PRELIMINARY & FINAL DRAINAGE PLAN

CARRIAGE MEADOWS SOUTH AT LORSON RANCH FILING NO. 2

PUDSP-19-005

Engineering Review

DETENTION POND WATERSHEDS
DRAINAGE PLAN
CARRIAGE MEADOWS SOUTH

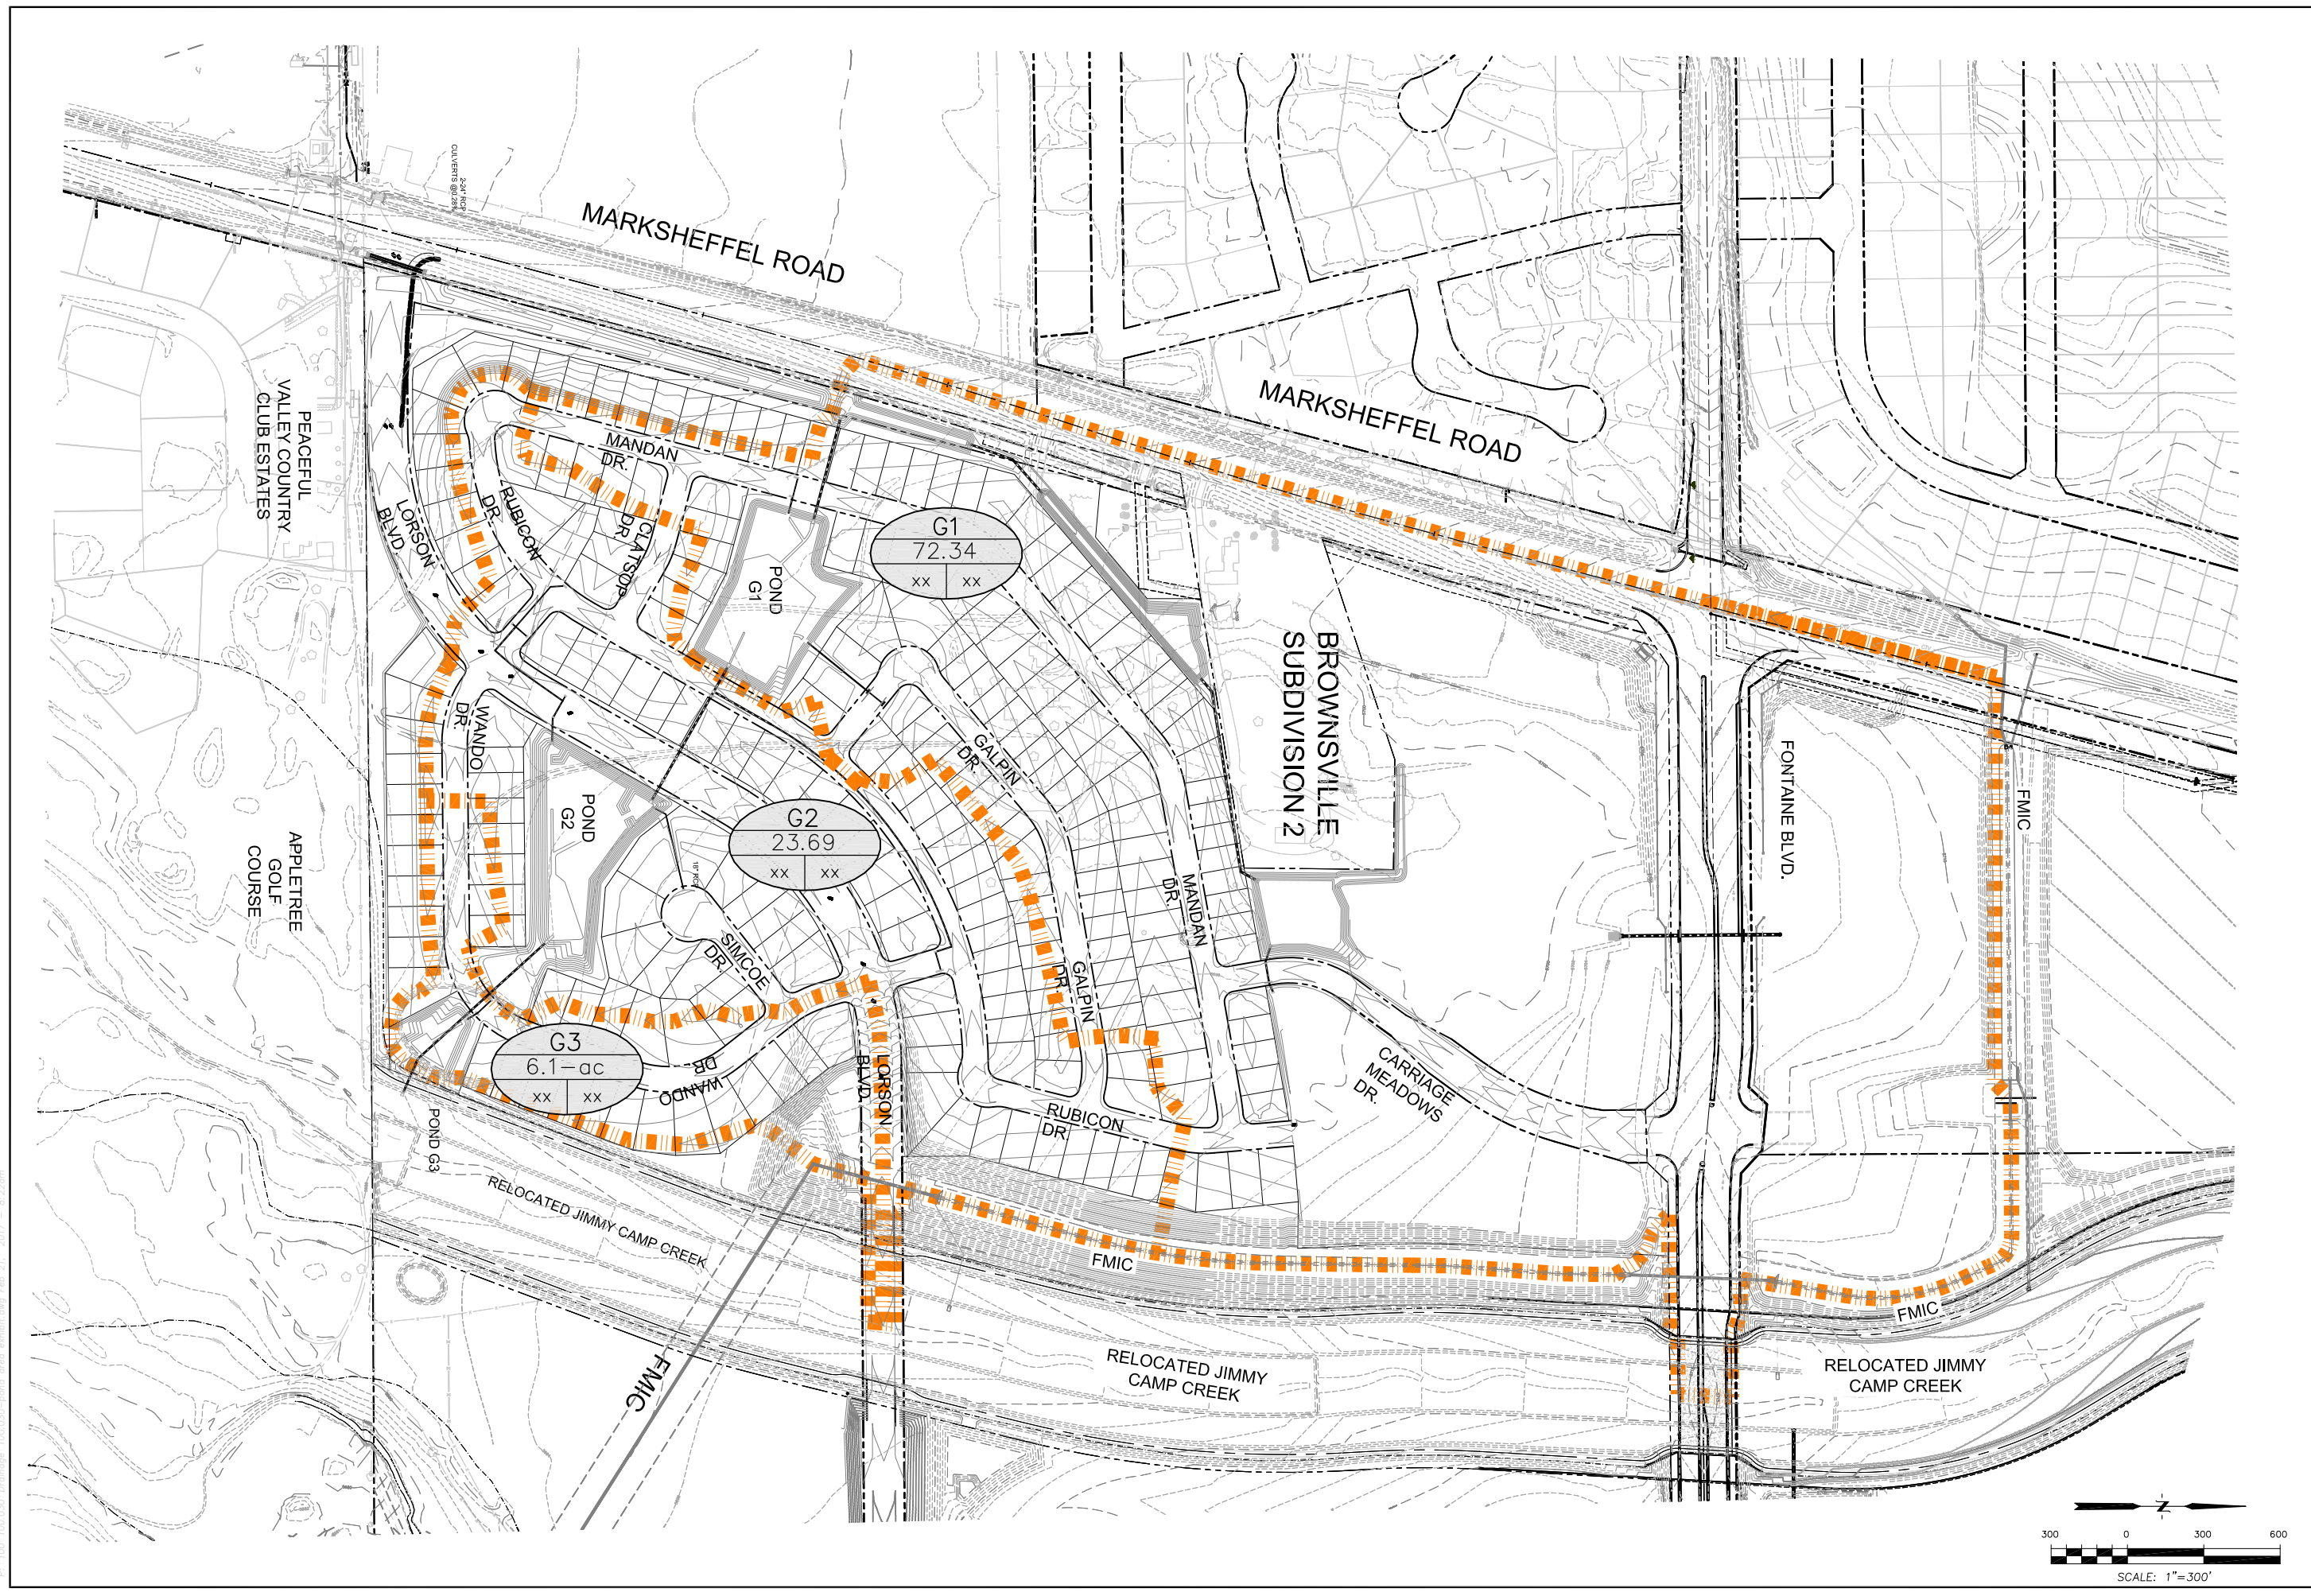
Can this be adjusted? Is the outlet structure designed to be updated with each additional development?

DATE:	JUNE, 2019
PROJECT NO.	100.046
SHEET NUMBER	1
TOTAL SHEETS:	1

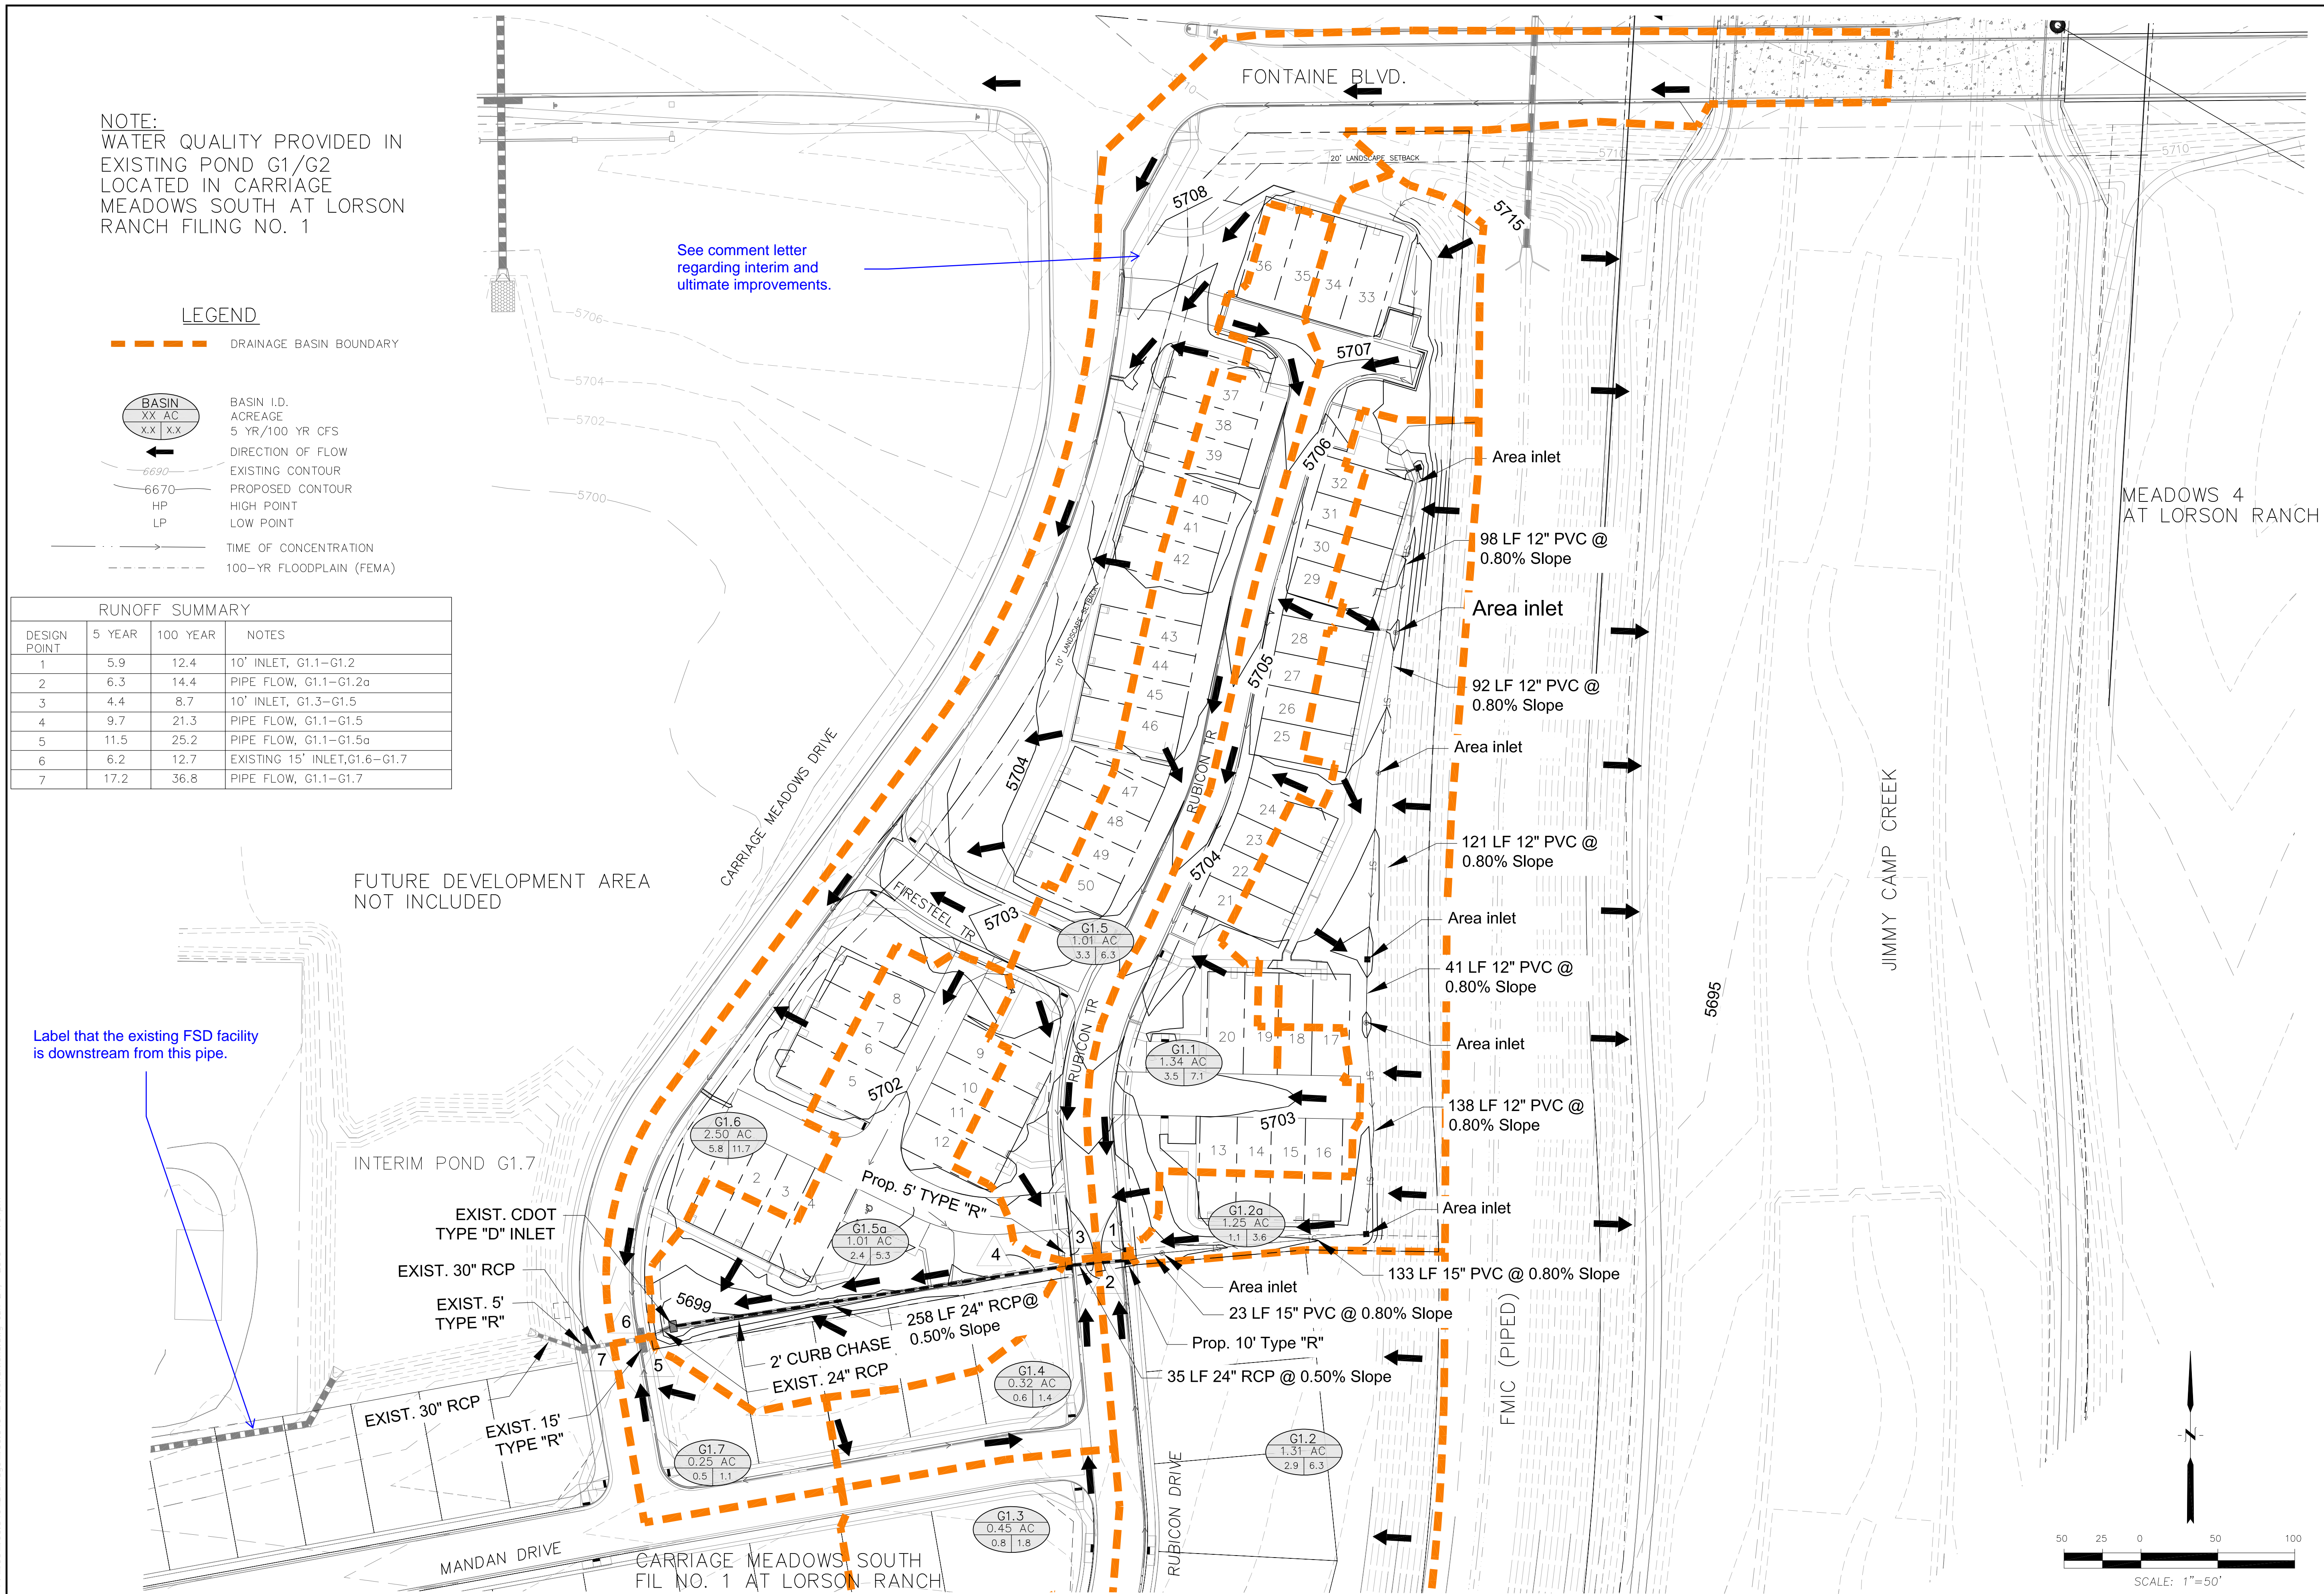
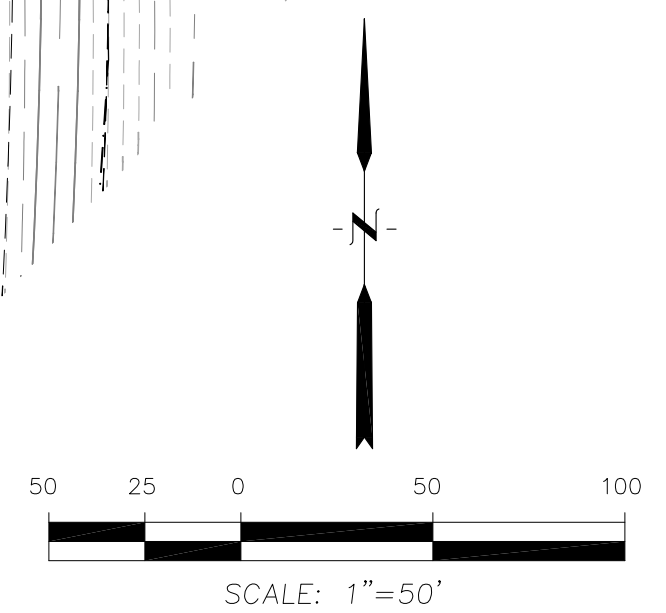
See comment letter
regarding interim and
ultimate improvements.

Label that the existing FSD facility
is downstream from this pipe.
